Delegated officer report for planning application

Application no. 144780/FO/2025

Proposal: External alterations including installation of entrance door, louvre screen and glass louvres.

Address: 88 - 100 Quay Street, Manchester, M3 4PR

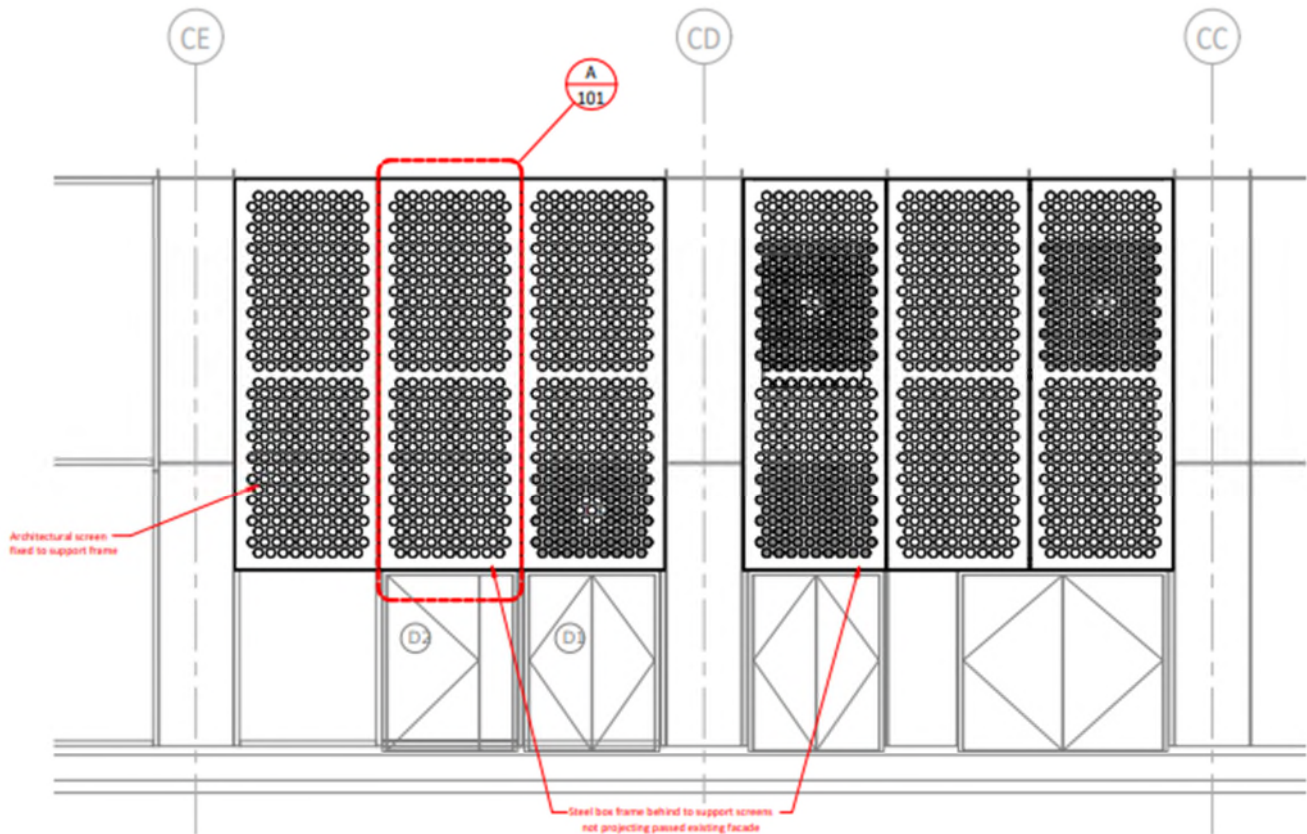
3no. louvre panels are proposed to be installed on the western elevation to improve ventilation support for the F&B occupier. The louvre panels will be fitted with stainless steel bird mesh and insect mesh, feature ducting at the rear of the panels and finished with a polyester powder coating.

The position of the louvres has been strategically chosen to contain the service infrastructure in one location and to minimise visual disruption to the Quay Street elevation as a result of increasing ventilation capacity.

The design of the louvres matches another louvre and louvres door nearby on the elevation.

The cumulative visual impact of these standard designed louvres was not considered to be acceptable by the City Council, hence the need for the second design element on the Quay Street elevation to mitigate any visual harm that may be caused – decorative panels.
